RE: Collin County Courthouse Addition  
Owner Project #R0508003.00  
Turner Project #1692600

Subject: PCO-66, Steel Revisions to the Penthouses

PCO No.: 066 R3  
 PCO Title: **Corrective Action at CMU Corners of Penthouse**  
 Project: Collin County Courthouse Addition  
 Project No.: R0508003.00

ATRIUM FLOOR TERRAZZO

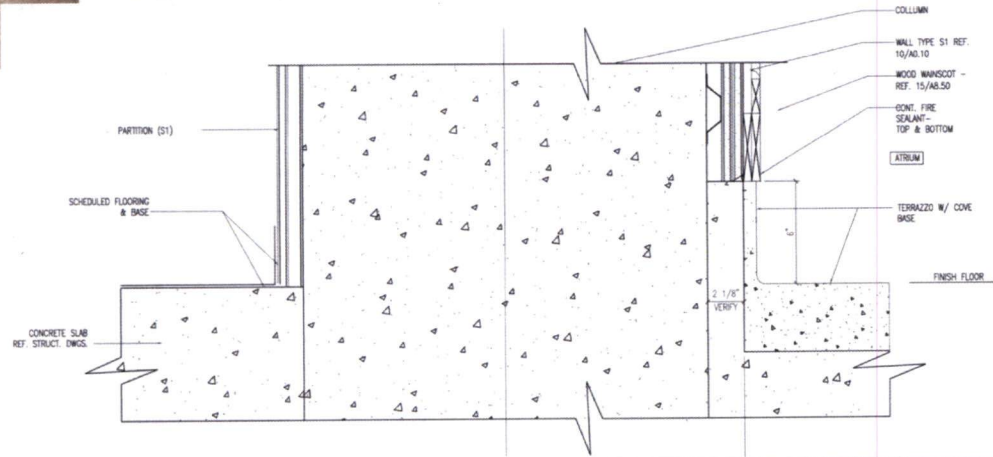
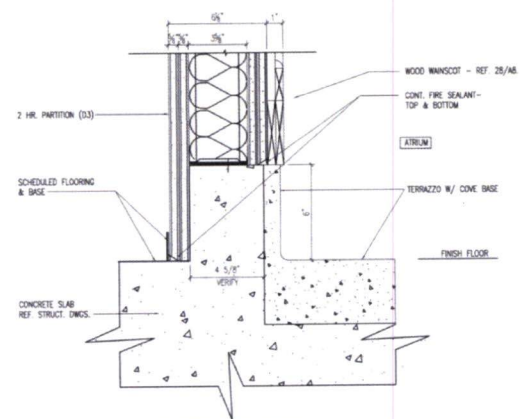
3. Interior curbs on Level 1 are shown to be 3" wide curb on 13/S4.02 and 4 5/8" on 17/A8.50. PGAL was not afforded the opportunity to clarify which dimension was to be followed. Currently, all curbs were installed at 3". The photo below shows what was thought to be an acceptable layout. However, after looking at the actual wall thickness to include 1/2" blocking at the veneer wall panels. The actual dimension from the face of gypsum finish on the corridor side is 1 1/4" plus 1/4" overhang of the panel over the terrazzo covered base. The curb must be provided per the Architectural drawings. The current curb face at the corridor may not be installed per detail 13/A8.50.

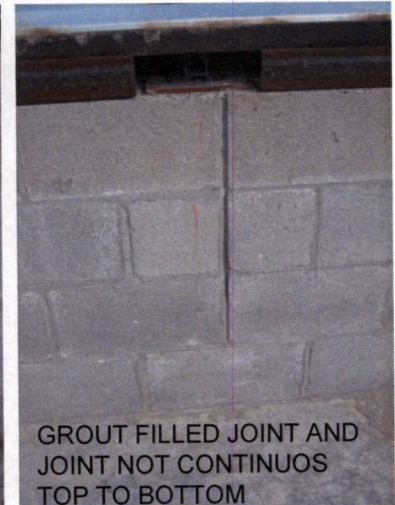
11. Control joints in parapet wall are not per Contract Documents. Control joints are not to be grout filled and should be continuous through the block from top to bottom of wall at minimum 30'-0" increments

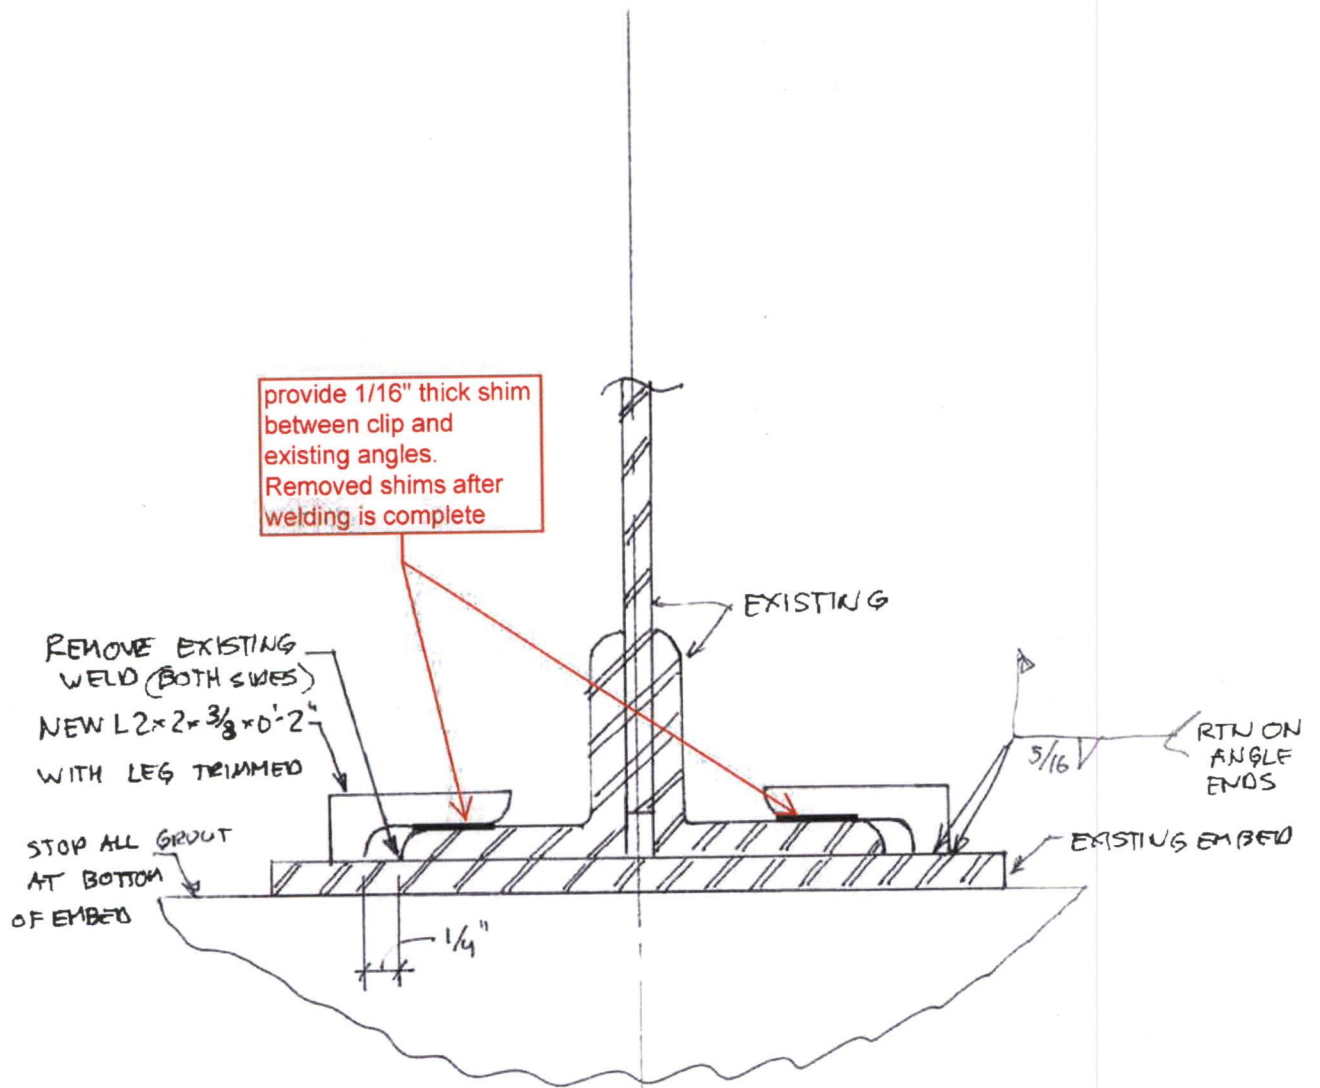
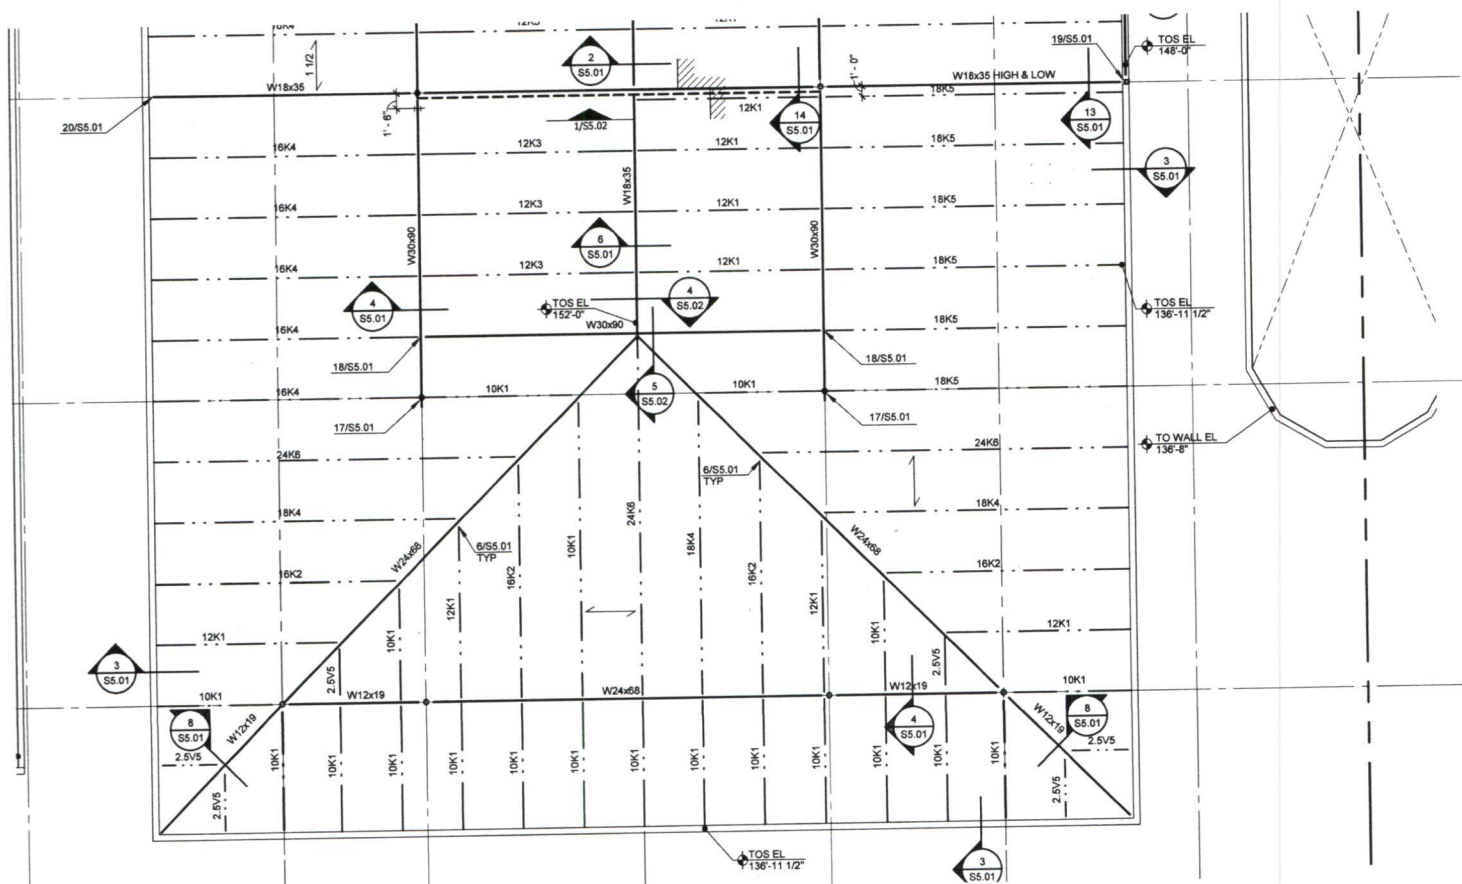
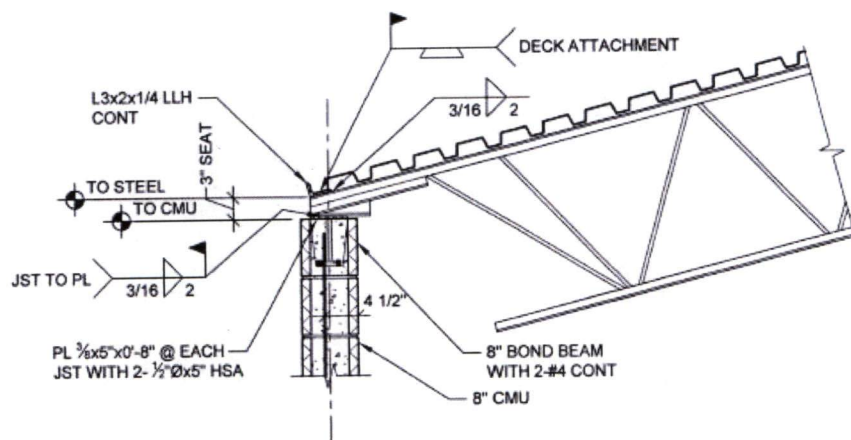
**Subject** Masonry Corner Condition - Resubmit of RFI #159 - Resubmit of RFI #183  
**Question** Please provide new masonry corner detail discussed between Turner and Matt Wagner on 3/22/11.

Please find the attached sketch to assist with the corner masonry detail, as discussed in the field between Matt Wagner and Turner Construction.

This detail should supplement previous details submitted for this typical area of construction.Â

The as built detailÂ was not sent for A/E review, but was drawn by the fabricator for field modification.Â
